PLANS AND DOCUMENTS
referred to in the
APPROVAL
Dated: **17/01/2024**

AMENDED IN RED
6/11/2023

PROJECT
FLORENCE STREET DEVELOPMENT

ADDRESS
Lot 1 on RP9232
9 Florence Street
NEWSTEAD

DRAWING
SITE PLAN

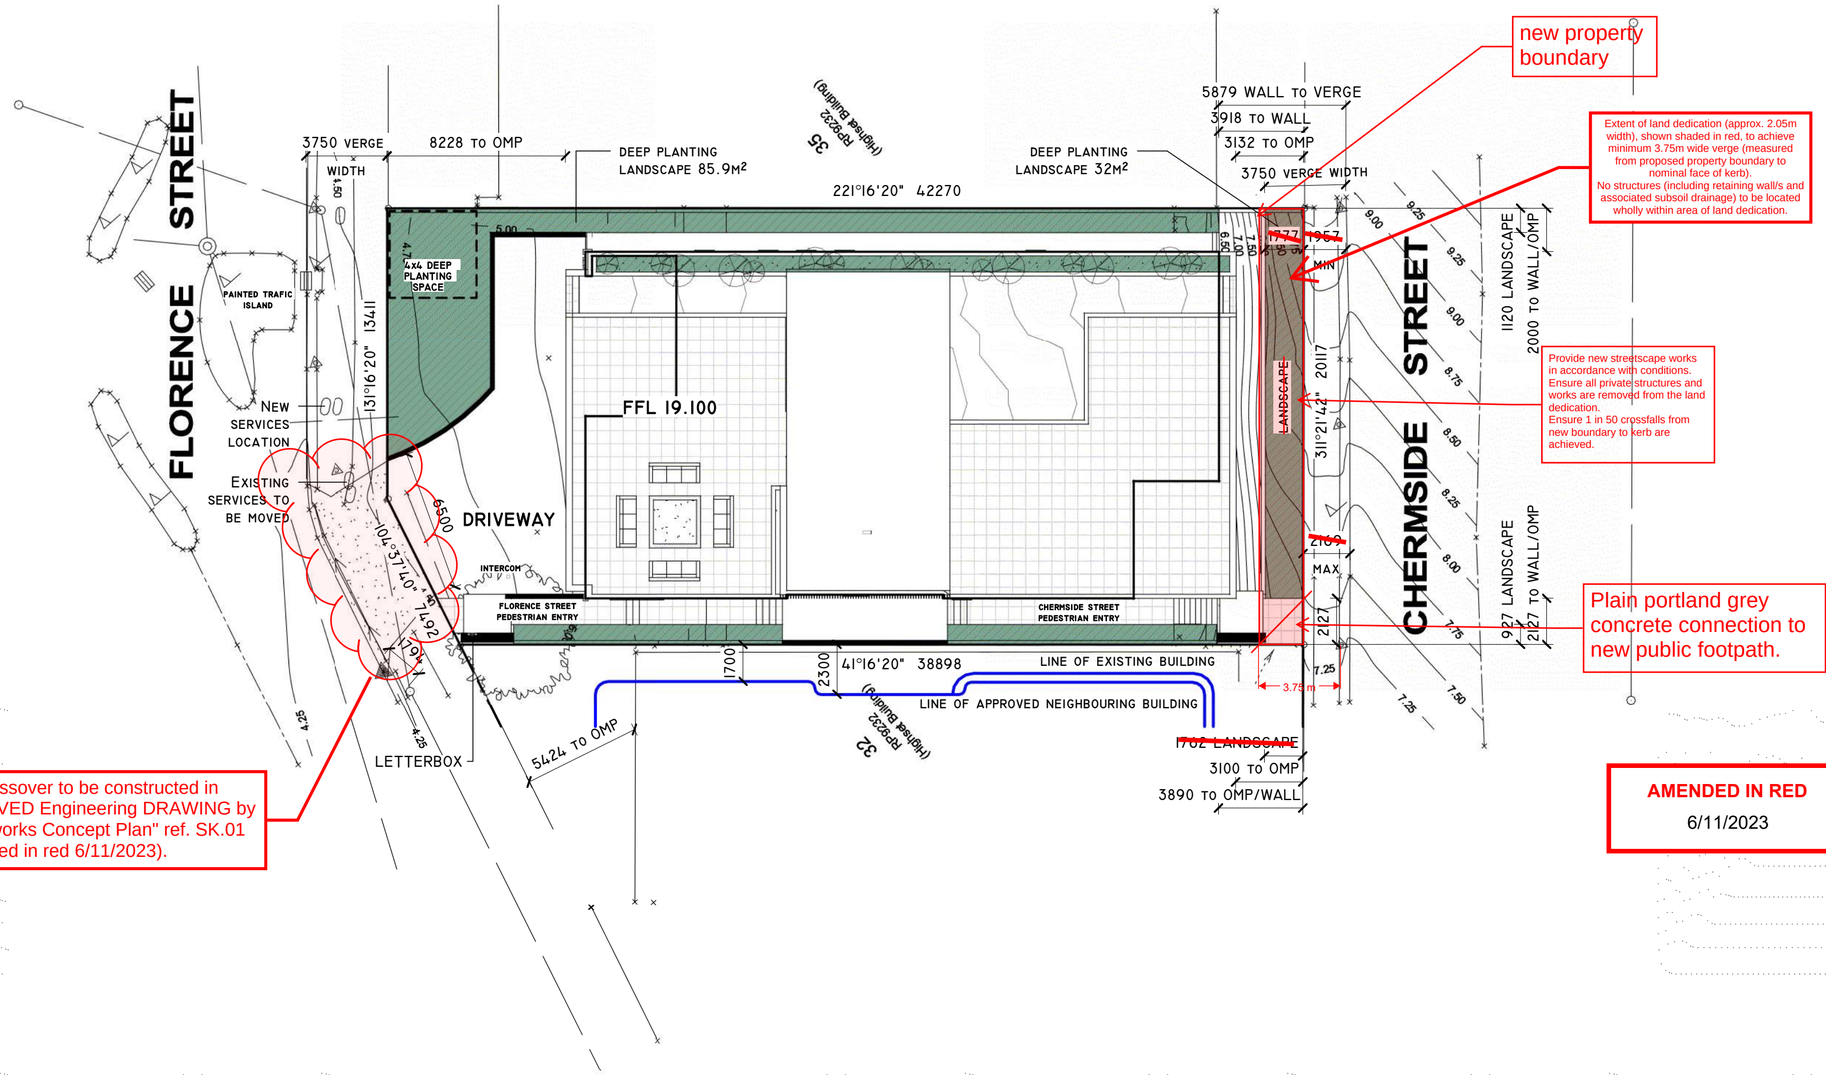
Access driveway/crossover to be constructed in accordance with APPROVED Engineering DRAWING by DEQ named "Civil Siteworks Concept Plan" ref. SK.01 Rev 1 (amended in red 6/11/2023).

DRAWING
BASEMENT PLAN

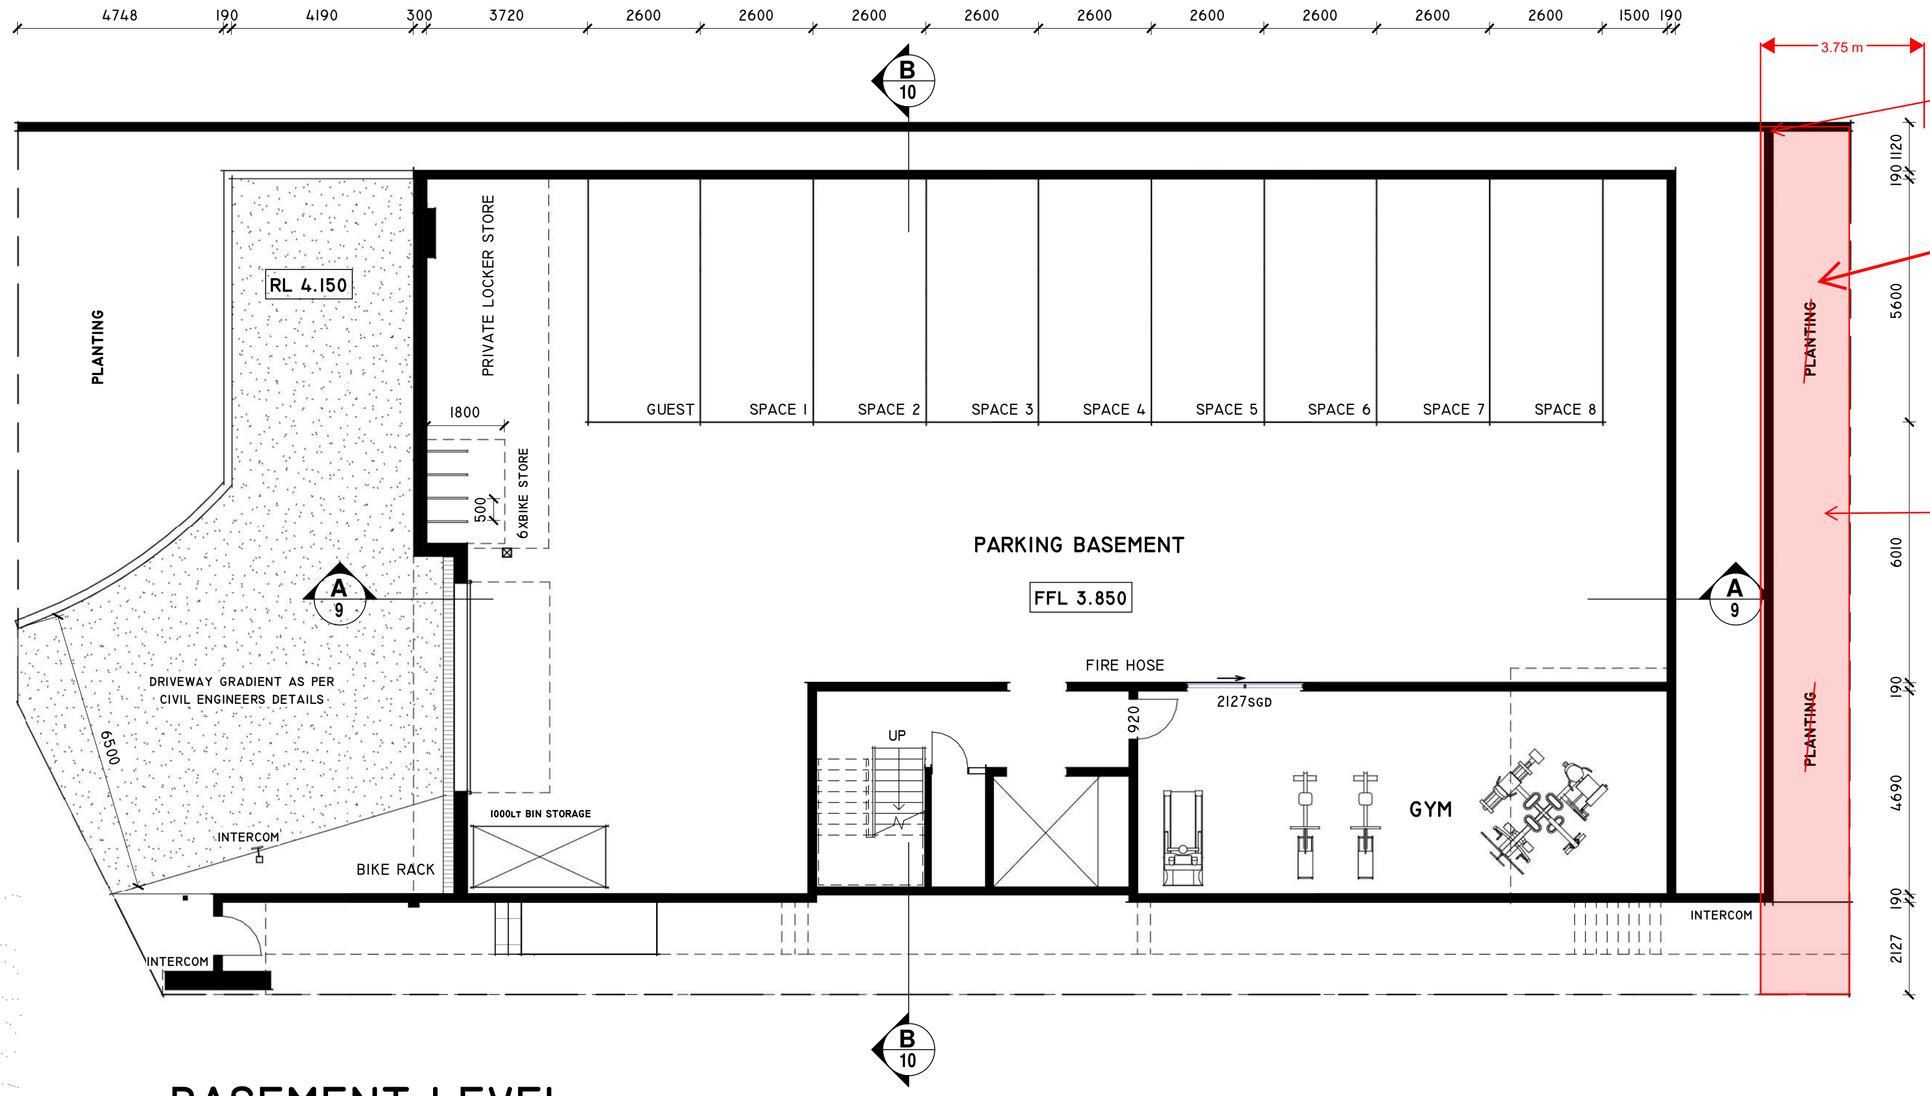
Extent of land dedication (approx. 2.05m width), shown shaded in red, to achieve minimum 3.75m wide verge (measured from proposed property boundary to nominal face of kerb).
No structures (including retaining wall/s and associated subsoil drainage) to be located wholly within area of land dedication.

Provide new streetscape works in accordance with conditions.
Ensure all private structures and works are removed from the land dedication.

NORTH WEST ELEVATION

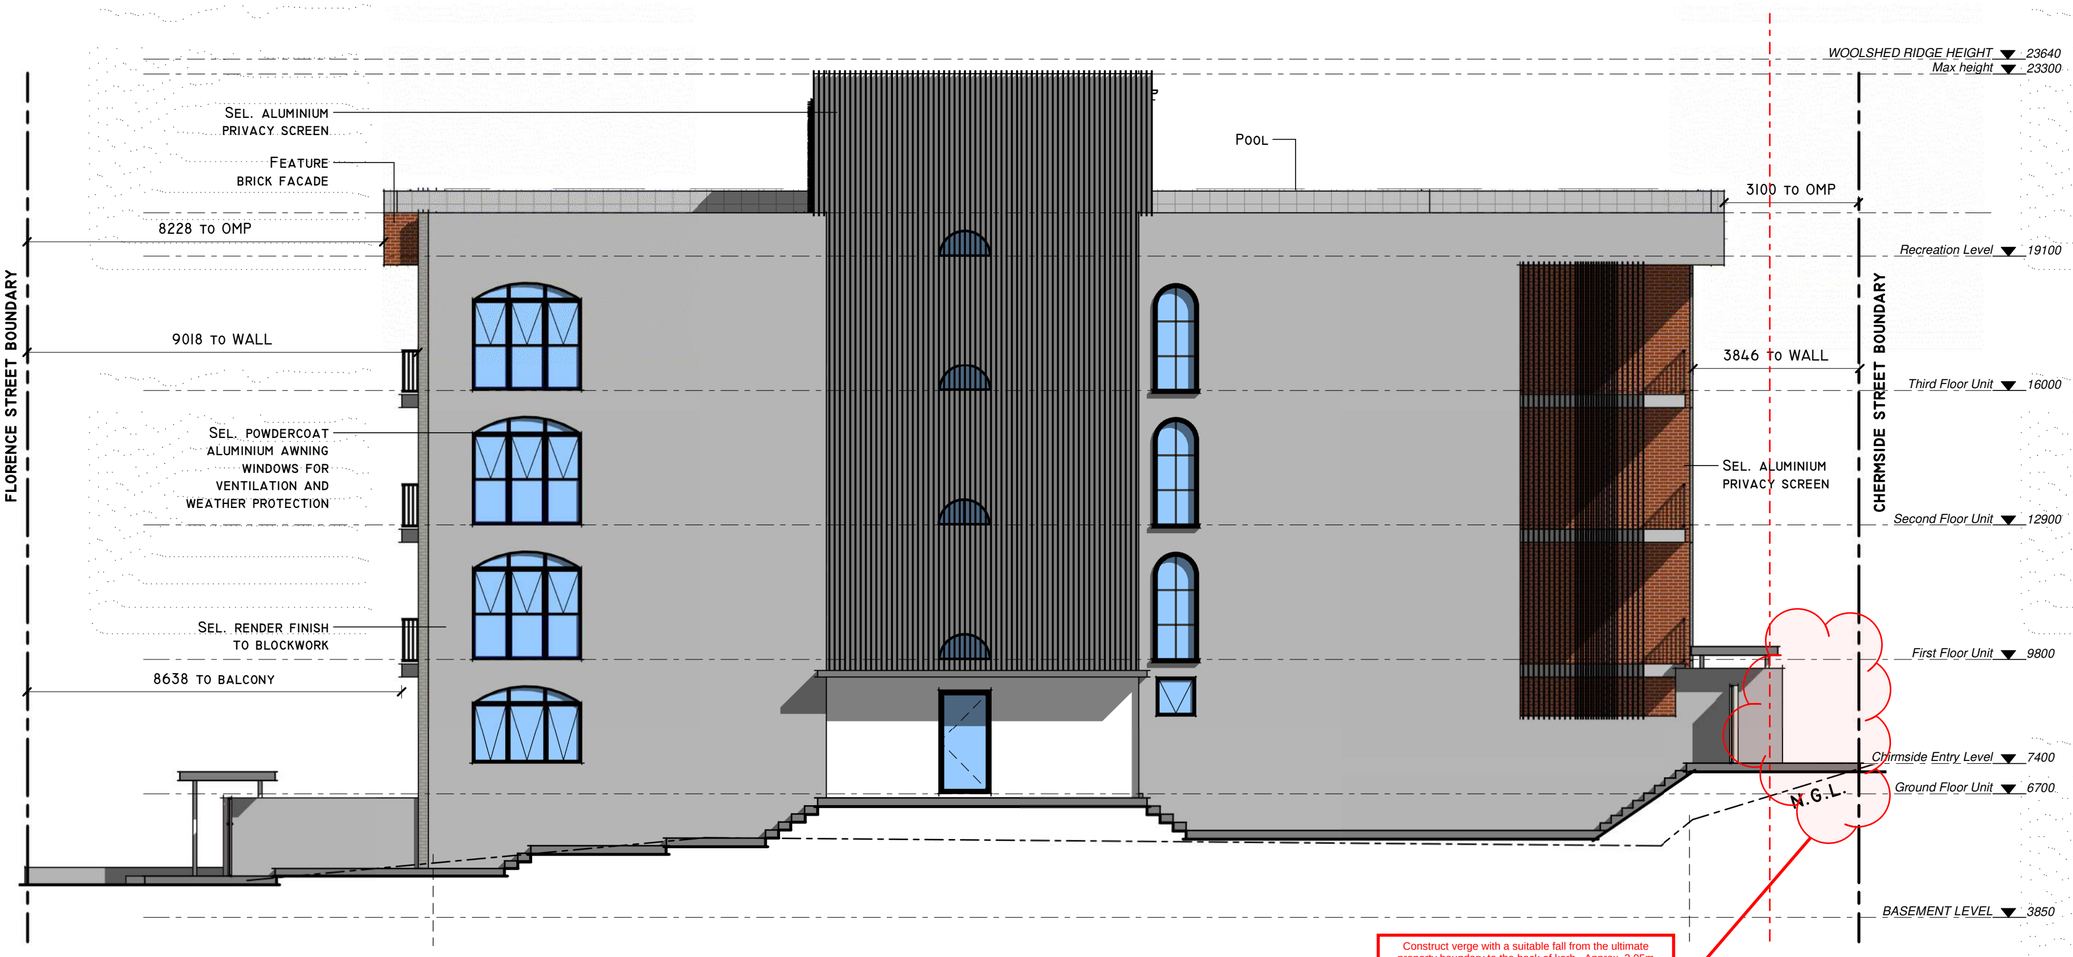
Construct verge with a suitable fall from the ultimate property boundary to the back of kerb. Approx. 2.05m widening required. No structures (including landscaping, retaining wall/s and associated subsoil drainage etc.) to be located wholly within area of verge widening/land dedication.

DRAWING
SECTION AA

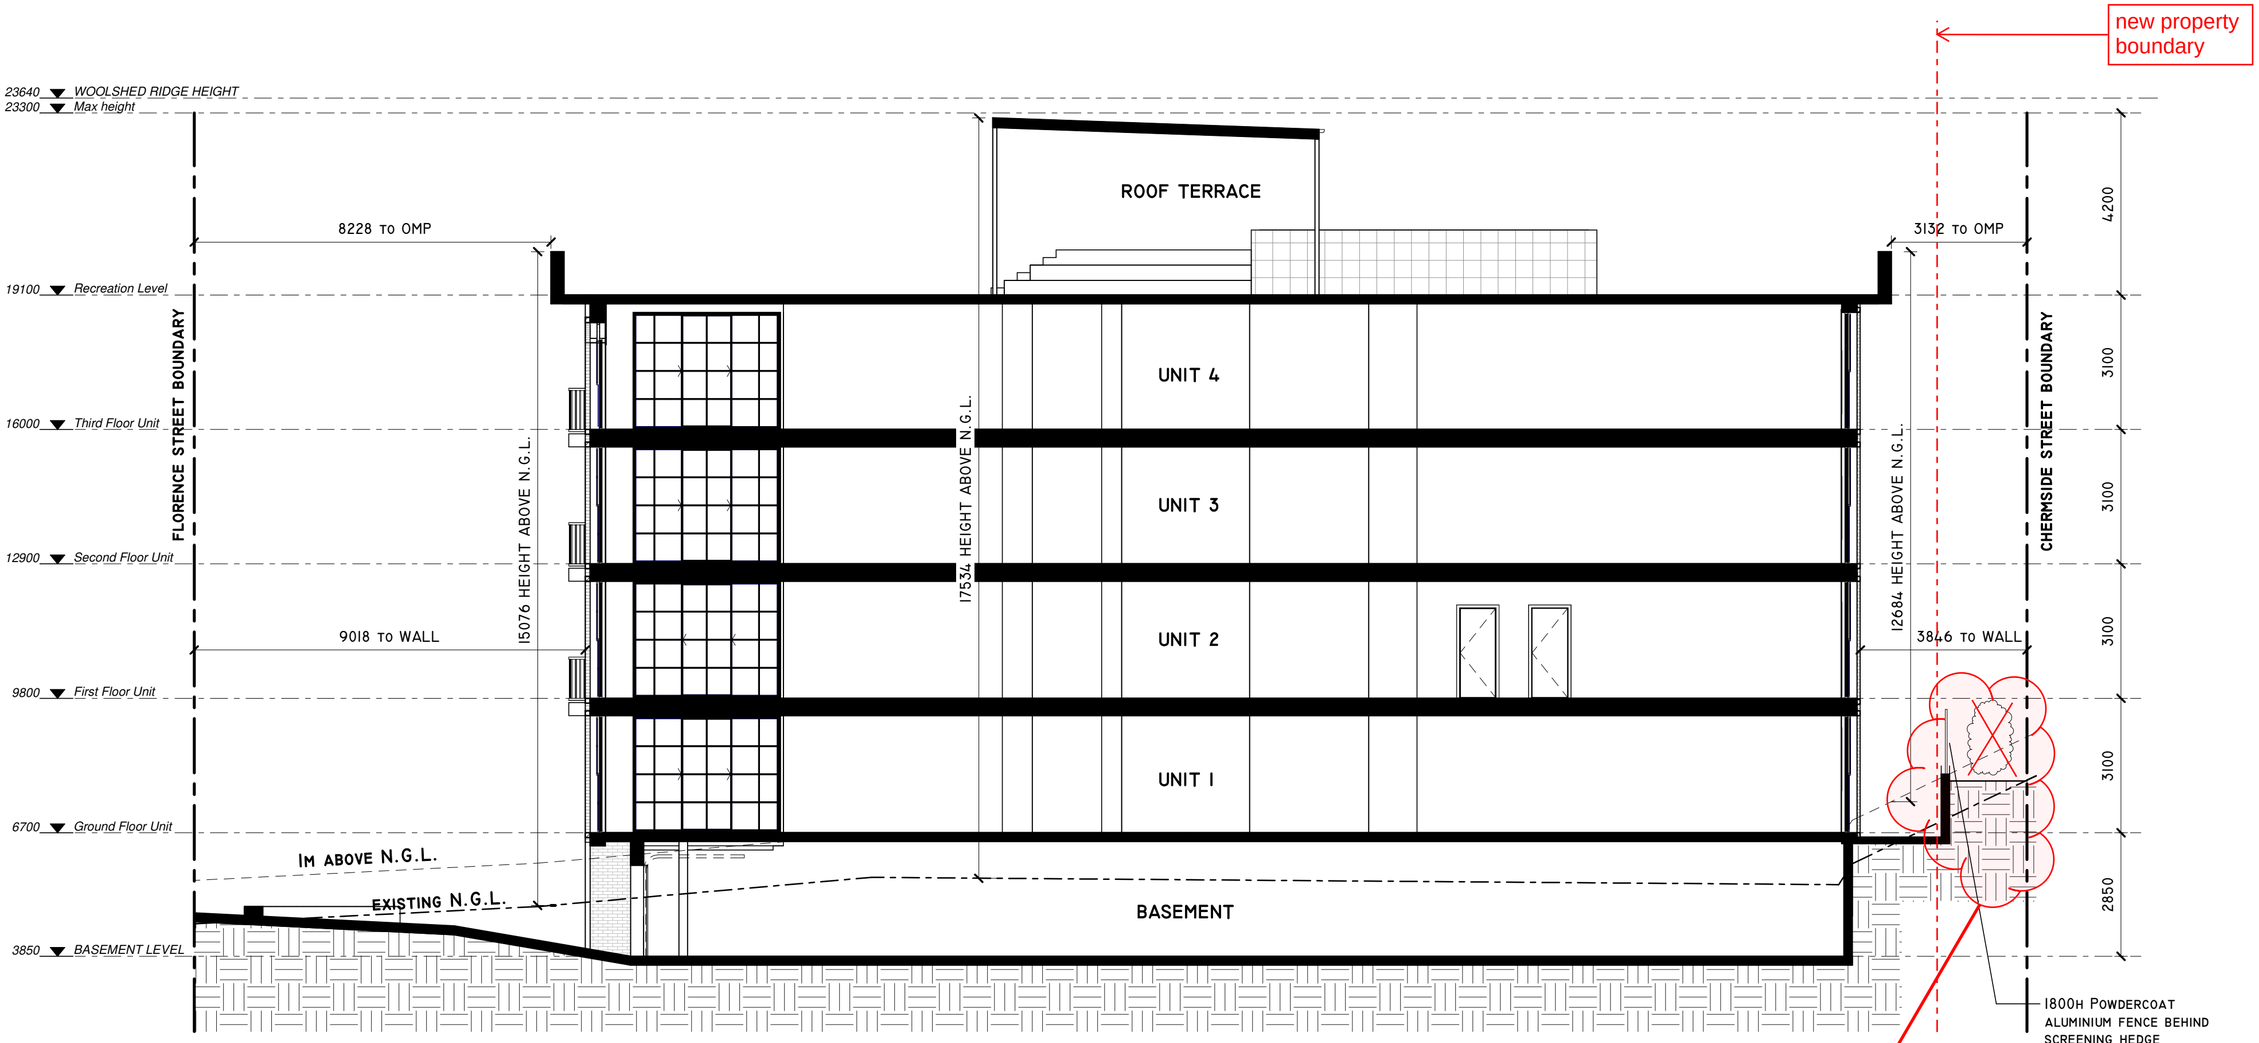
Construct verge with a suitable fall from the ultimate property boundary to the back of kerb. Approx. 2.05m widening required. No structures (including landscaping, retaining wall/s and associated subsoil drainage etc.) to be located wholly within area of verge widening/land dedication.
